COUNCIL ITEM AGENDA REQUEST FORM

Meeting Date: 11/16/2023 **Staff Contact:** Phillip Trocquet

Item Description:

The applicant, Mr. Steven Gulas, has submitted conceptual information on a proposed 90-room hotel for the property with a conceptual site plan and example images of other hotels for architectural reference.

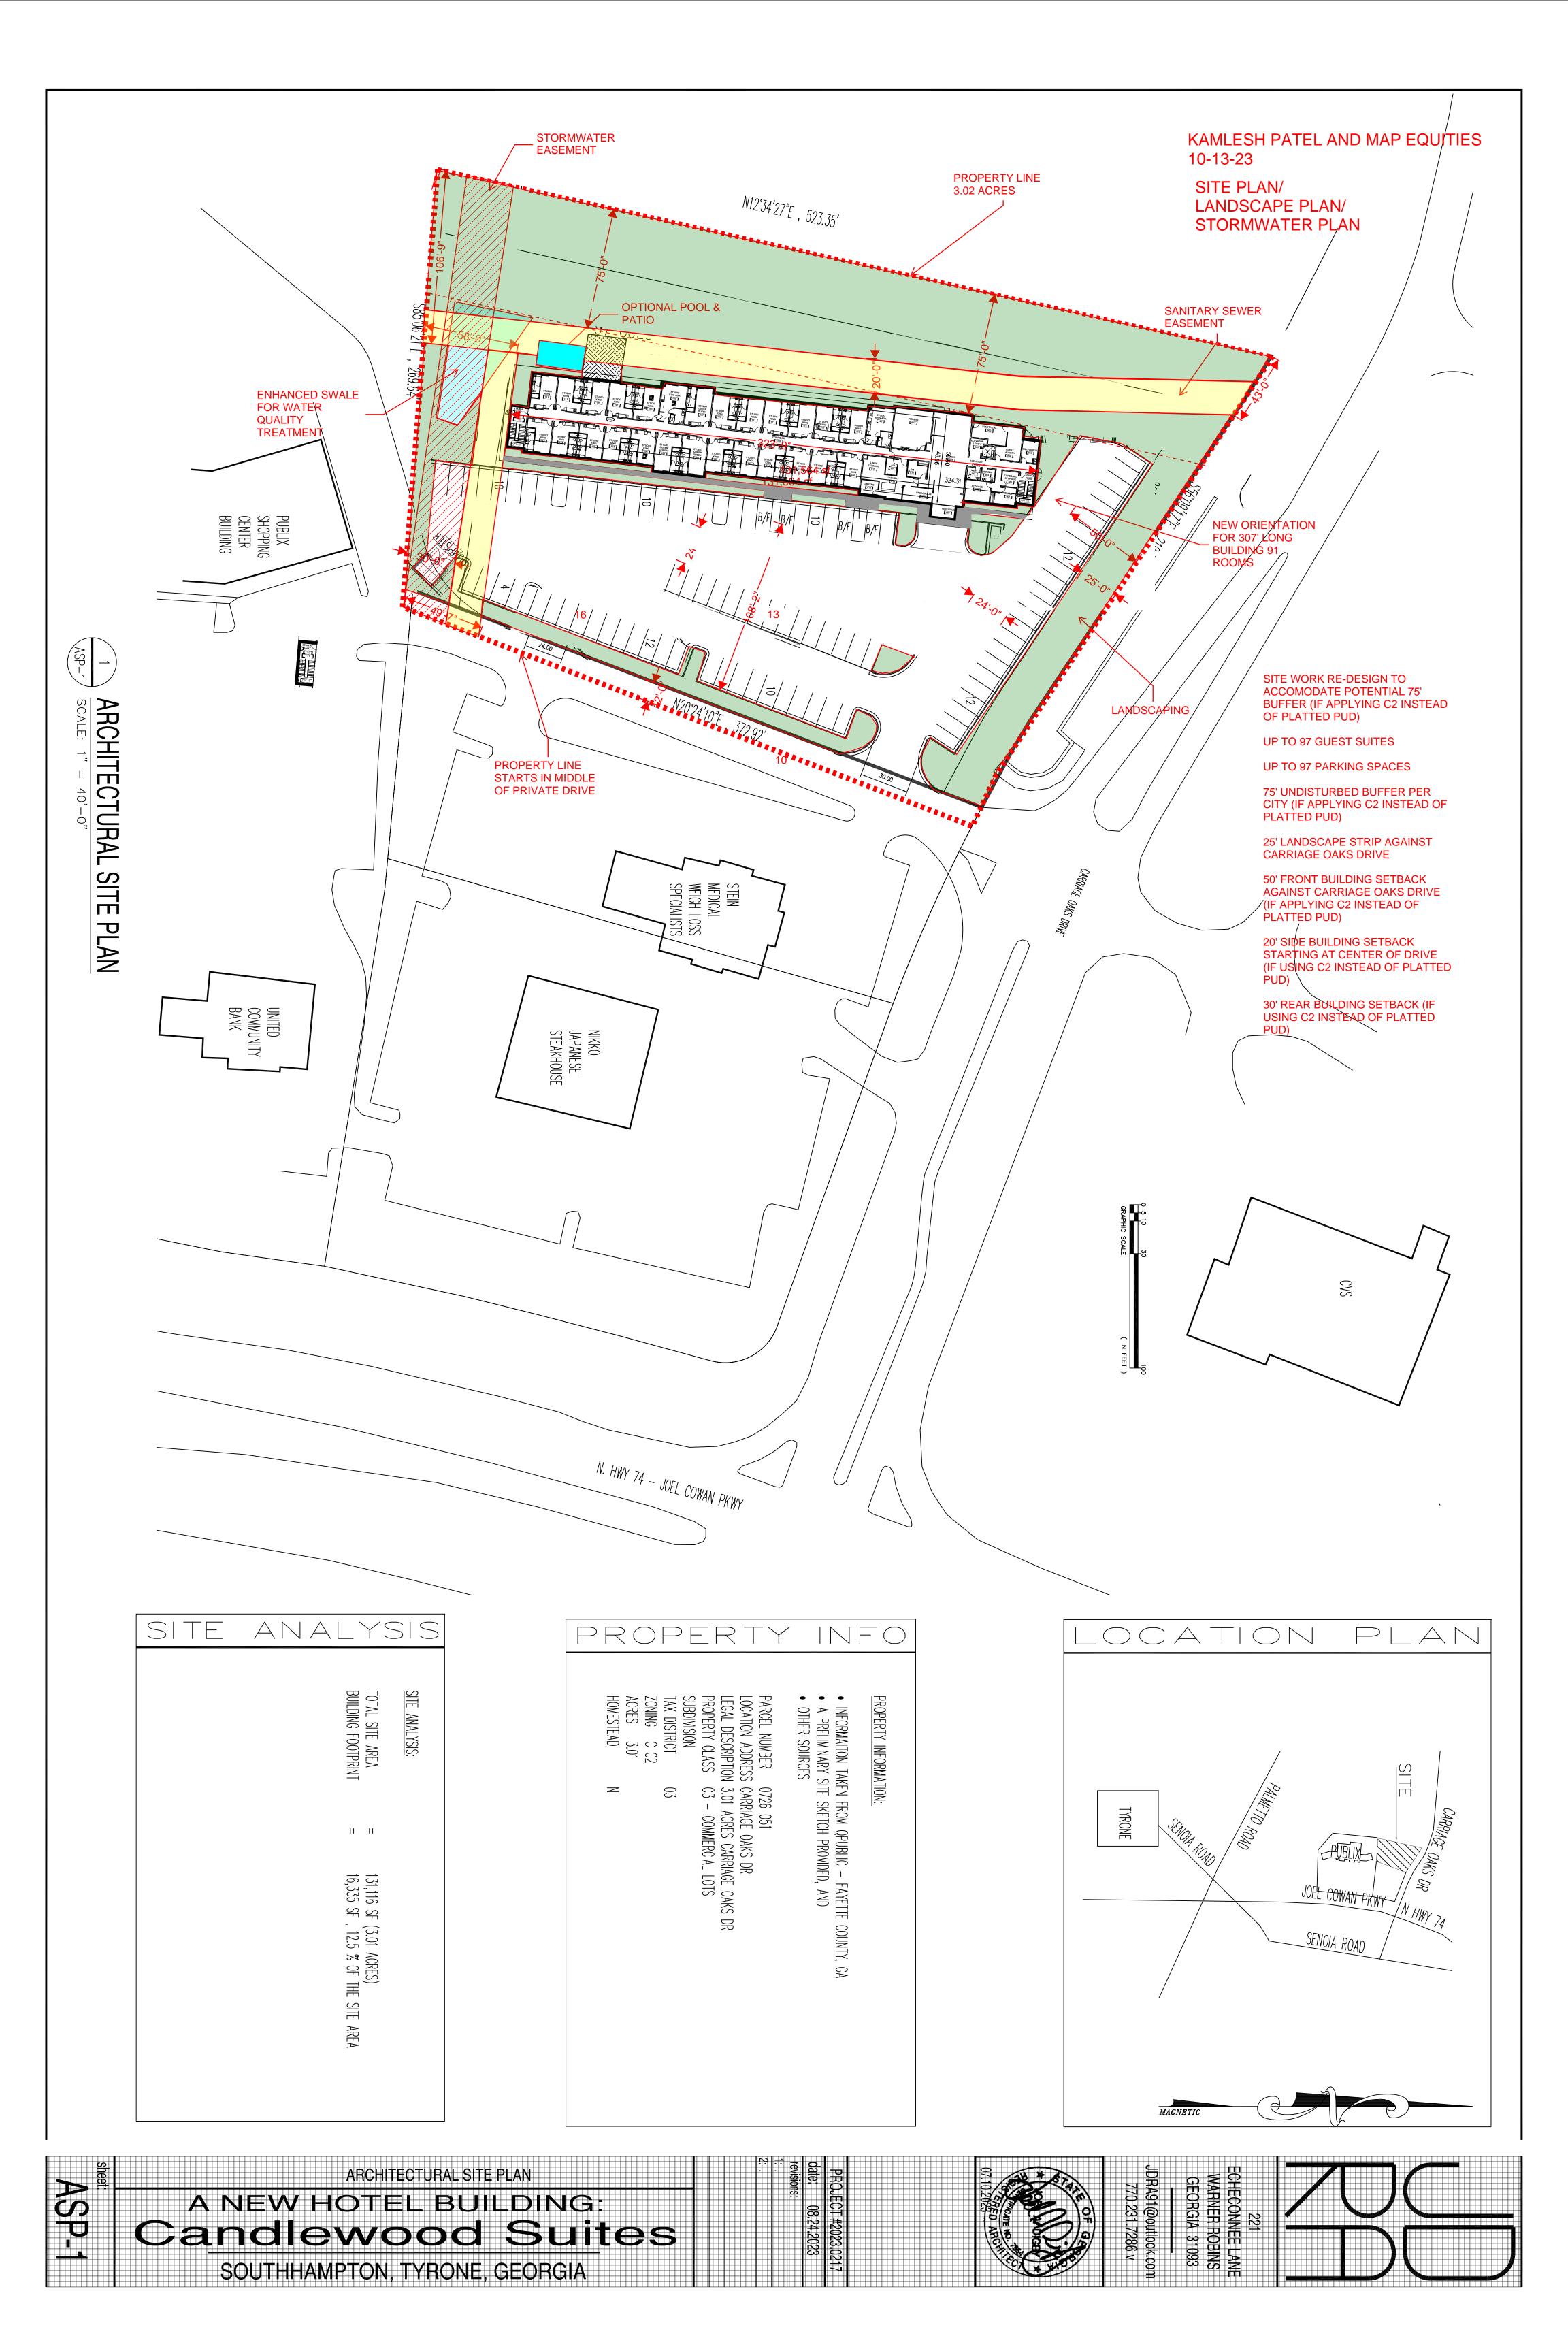
- The conceptual landscaping areas do not detail how they are to be in conformity with the standards of the SR-74 Quality Growth Overlay District.
- No submission of architectural renderings signed by an architect or other appropriate professional have been submitted that clearly indicate the following:
 - o Exterior elevations drawn to scale with color rendering
 - o Proposed Colors, materials, and textures for structures.
 - o Location of all exterior utility facilities including any rooftop units.
 - o Proposed signs and locations including size, color and material.

Given that no rendering has been submitted for this proposed project, staff does not recommend approval of this Certificate of Appropriateness Application.
